A/C TYPE EC 155B  
 A/C REGN 9M-SAB S/N6583  
 TYPE OF CHECK \_\_\_\_\_

DEFECT AND RECTIFICATION WORKSHEET/CERTIFICATE OF RELEASE TO SERVICE

**No. 67A004**

**SUBJECT :** ROTORS FLIGHT CONTROL  
Collective low pitch value reduction

Figure 2

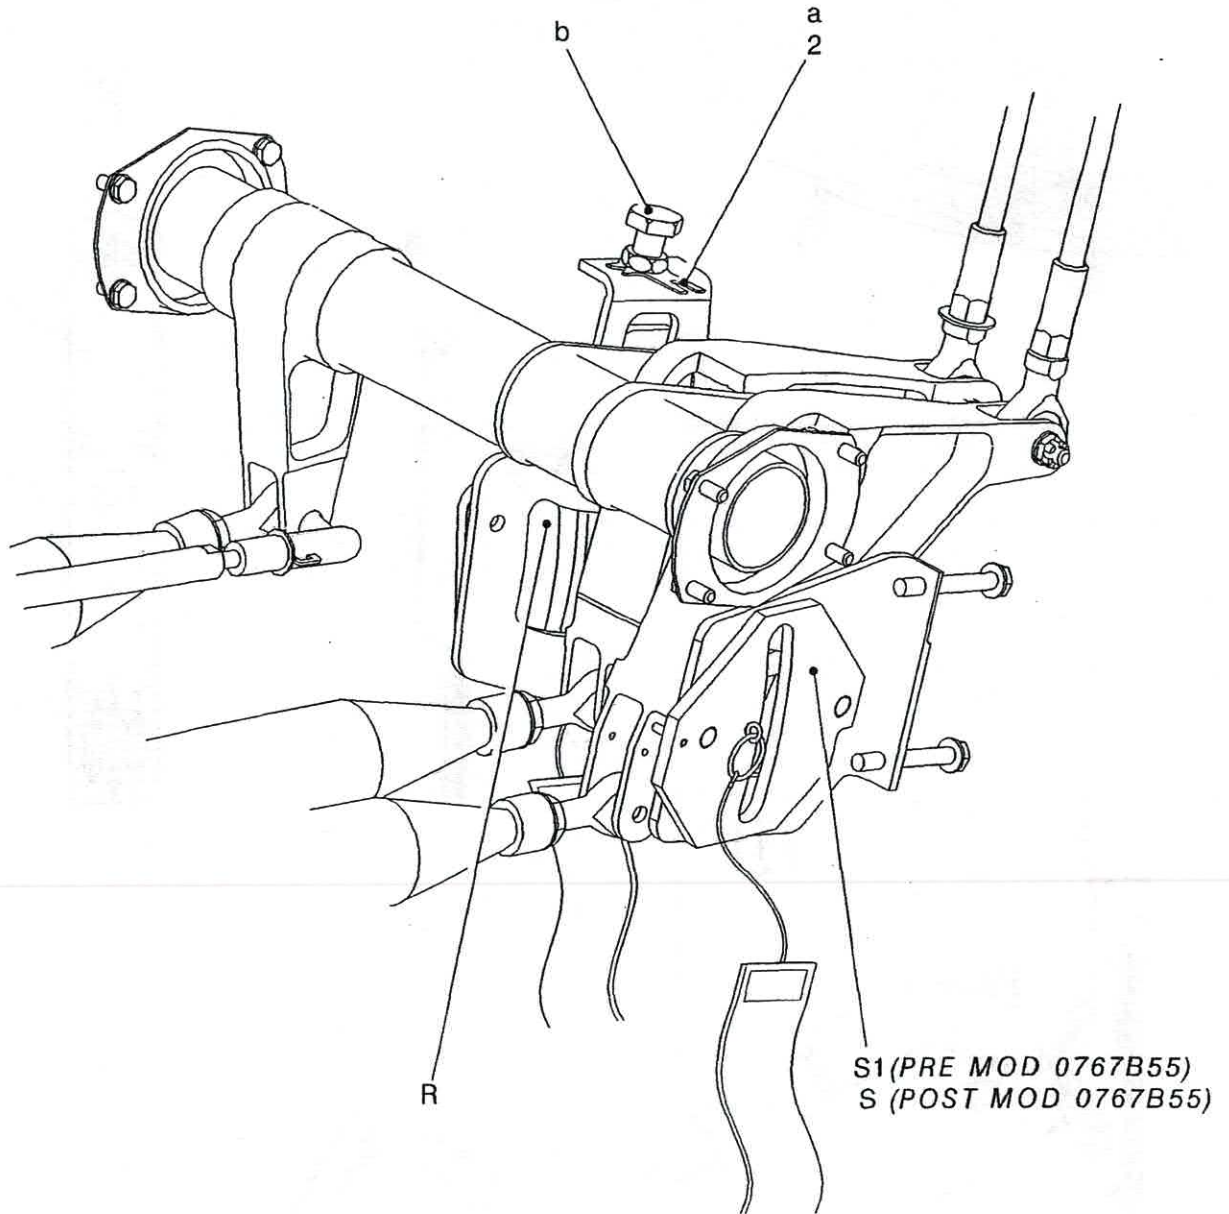
- Changing the low pitch stop rigging from  $-2^{\circ} 39'$  to  $-1^{\circ} 45'$ .
- Replacing the "low pitch" collective lever lockplate by a new lockplate set to the new rigging.

### 2.B.2.b. Low pitch stop rigging post-MOD 0767B62 (Figures 1 and 2)

- Set collective lever to low pitch in order to obtain a collective pitch of  $-1^{\circ}45'$  or  $-9'$  (yellow sleeve, mean value recorded on azimuths  $12^{\circ}$  and  $192^{\circ}$ ) on clinometer (E).
- Secure lever in this position via the friction lock.
- Replace lockwasher (a) by washer (2).
- Bring setting screw (b) into contact on collective lever pin.
- Tighten locknut as per Work Card 20.02.05.404 (MTC).

- After obtaining the values prescribed in this table, fold back lockwasher (2) onto the fitting and the locknut as per Figure 2
- Jack down the aircraft to its landing gears as per Task 08-20-00-821 (AMM).

Figure 3

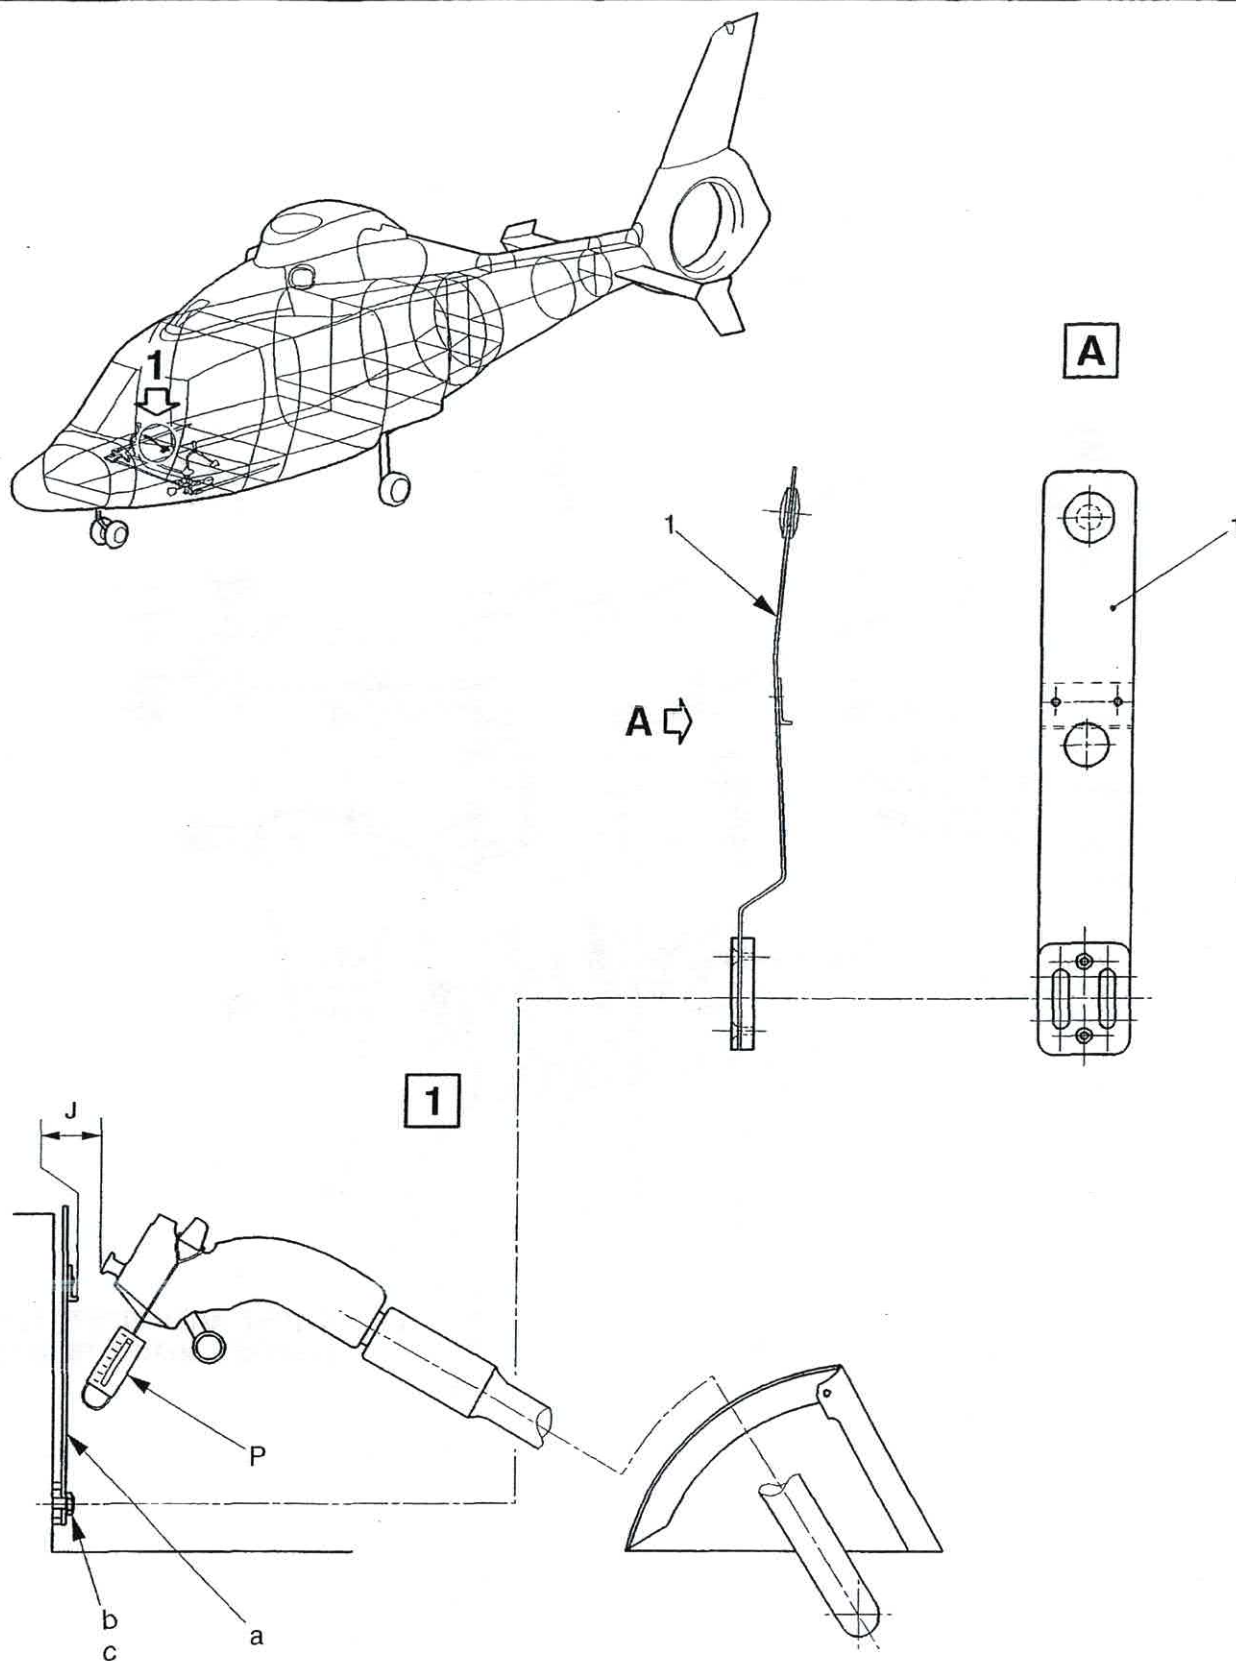
2.B.2.d. Installing the collective pitch locking assembly (Figure 3)

- Remove lockplate (a) and retain bolts (b) and washers (c).
- Install locking assembly (1) and secure without tightening, by means of bolts (b) and washers (c).

2.B.2.e. Adjusting the collective pitch lockplate (Figure 3)

- Pressurize the RH or LH hydraulic system.
- Adjust the lockplate so that the collective lever can be unlocked by exercising a pressure comprised between 11 and 14 daN on the pilot's collective lever grip, by means of spring balance (P), as per Figure 3 detail 1.
- Check that play  $J = 3$  mm is effective between the collective lever pin and the lockplate angle, as per Figure 3.
- Tighten both bolts (b).
